Rhythm Fashion Ltd.

14 June 2026

1. Building Information

Observation-1: High stress in foundation (Main Production Building)

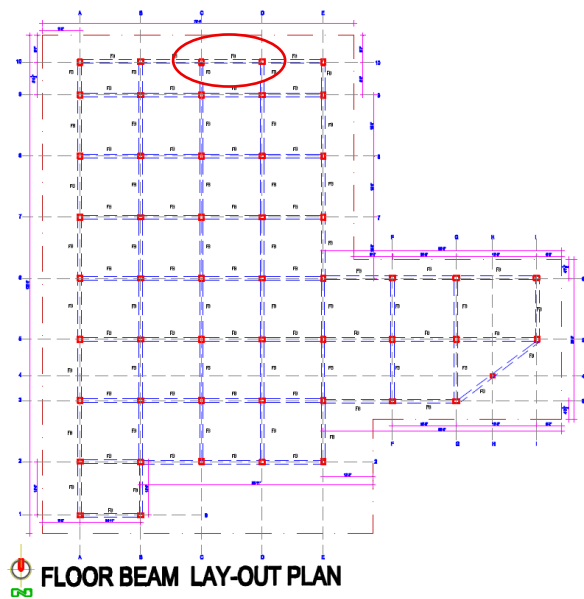
Description: Cursory calculation indicates FoS of foundation (single footing) below the design limit considering the floor live loading 2kPa and allowable bearing capacity of soil 1.0 Tsf (FoS-2.5) at 2.9 m depth. Building engineer is required to review the design, loads, and foundation stresses.

Also, the design report of the Main Production Building was available on-site. However, only four sets of concrete core test reports from the column were available. But no material test report was available for the beam and slab (flat-plate portion). Moreover, credible drawings were not available for the foundation details. The building engineer is required to confirm the foundation system, revise the design report in accordance with BNBC 1.9.1, verify in situ concrete strength by taking 100 mm-diameter concrete cores from the structural members (Beam and Slab), and submit the design documents to RSC for detailed review.

Item No.	Observation	Action Plan	Timeline
1.	High stress in foundation (Main Production Building)	As part of the Detailed Engineering Assessment (DEA), the building engineer is required to review the design load, foundation stresses, and suggest proper remedial actions.	within 6 weeks

2.		Verify in-situ concrete strength by taking 100 mm diameter concrete cores from the structural members (foundation, Beam and Slab)	within 6 weeks
3.		Building engineer is required to confirm the foundation system and update the foundation check as part of the design report and submit it to RSC for review.	within 6 weeks

Floor beam layout

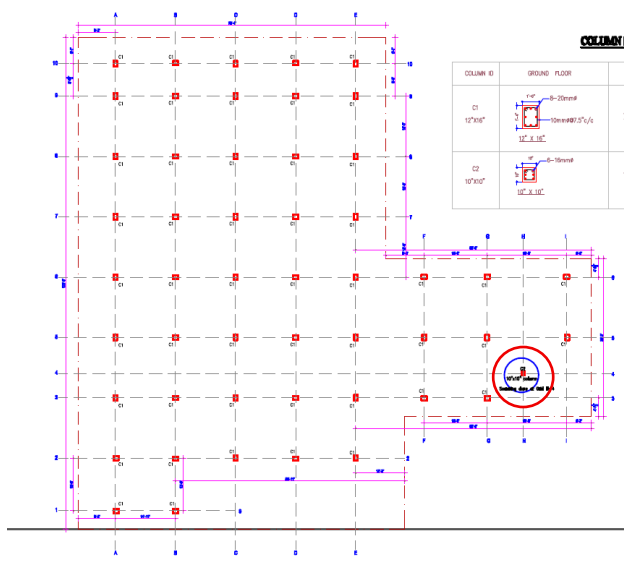
Misalignment of the beam from the column joint

Description: In the provided drawing, one beam is found to be misaligned, and one column is found rotated.

Building engineer is required to survey the structure and update the as-built drawing.
